Service Advisory

MTD-213

2 and 3 Stage Snow Throwers

Subject: A few of the 2016 Production 2 and 3 Stage Snow Throwers had a running change made to the belt keepers to correct an interference issue.

Figure 1

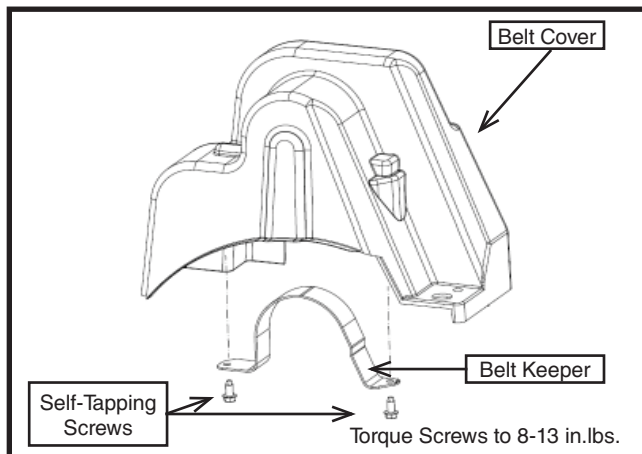
Purpose: Some 2016 built 2 and 3 Stage snow throwers have been found to have a slight interference between the engine pulley and the stamped steel belt keeper inside of the belt cover. This interference may be noticed by a metallic rubbing sound and a visual inspection of the belt keeper. See Figure 1.

Corrective Action: Order a new belt keeper, part number **790-00689A**, and install it into the cover using the two self-tapping screws. Be careful not to overtighten the screws and strip out the plastic. Torque them to between 8 and 13 in.lbs. See Figure 2. Reinstall the belt cover, start the unit and listen for the metallic rubbing sound. This new belt keeper should correct the interference problem.
